INFORMATION LETTER 010

TITLE: Rotax 912ULS airbox seal

MODELS AFFECTED: All models fitted with Rotax 912ULS composite airbox

Figure 1: Filter edge seal and airbox clips

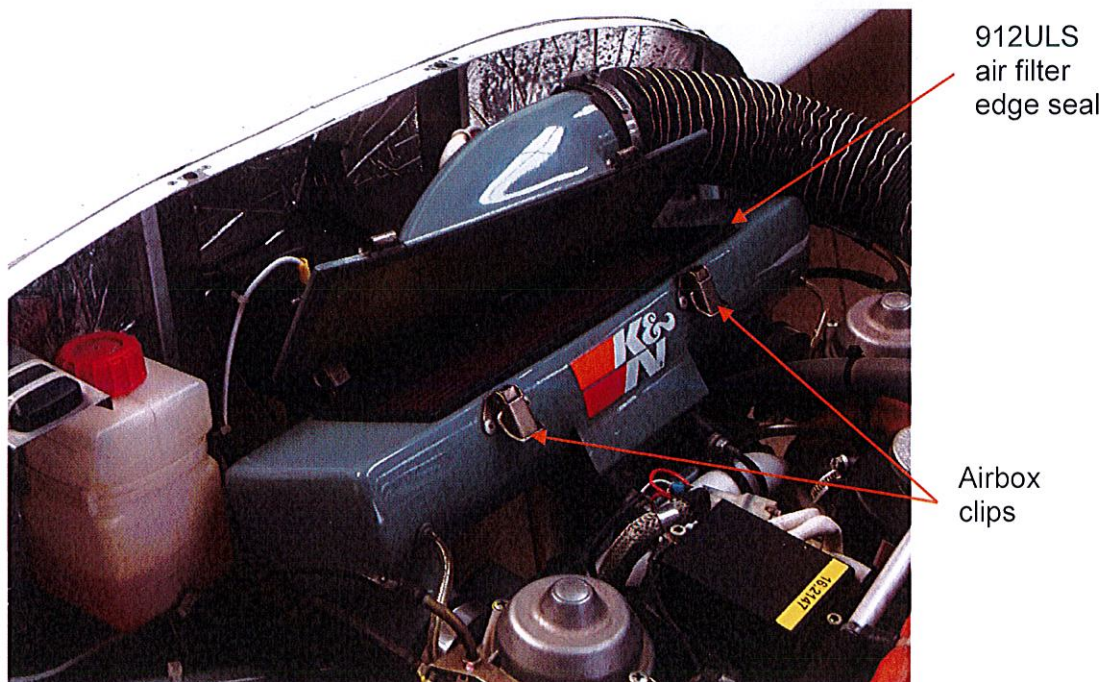
REASON: During initial fitment of the 912ULS air filter, the edge seal (see Figure 1) of the air filter creates a tight seal to prevent ingress of water and other foreign particles into the airbox through its lid. However, the airbox lid may develop some play due to flattening of the air filter edge seal with time.
